TO: Mercedes-Benz Dealer Principals, General Managers, Sales Managers, Service Managers, Parts Managers	FROM: Gregory Gunther, Senior Manager, Vehicle Compliance and Analysis, Engineering Services
RE: <b>Recall Campaign Launch Notification</b> <b>Add Inspection Gauge and Supplemental Booklet for Checking Rear Brake Pads</b> <b>MY19-21 A-Class, CLA, GLA and GLB (177, 118, 247 platform)</b>	DATE: February 16, 2024

Campaign No.2024010010, February 2024

SUBJECT: **Model A-Class, CLA, GLA, and GLB (177, 118, and 247 platform)  
Model Year 2019-2021**

## **Add Inspection Gauge and Supplemental Booklet for Checking Rear Brake Pads**

Figure 1 (Gauge A 000 583 06 42)

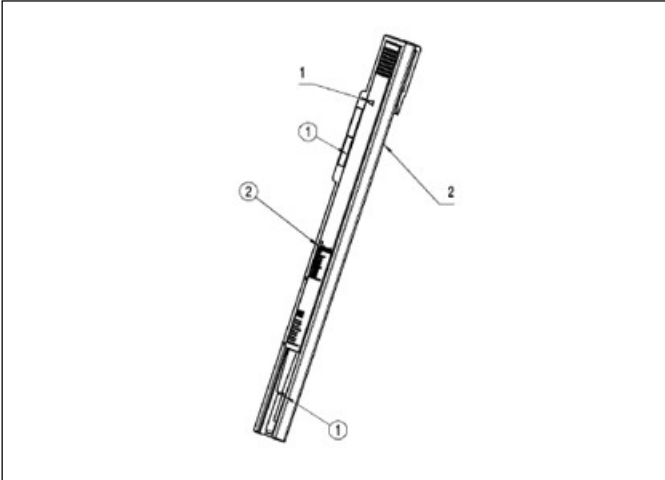
1. Open vehicle booklet and check whether gauge (**Figure 1**) is present; enclose if necessary.
2. Check whether supplementary booklet (**Figure 2**) is present; enclose if necessary.
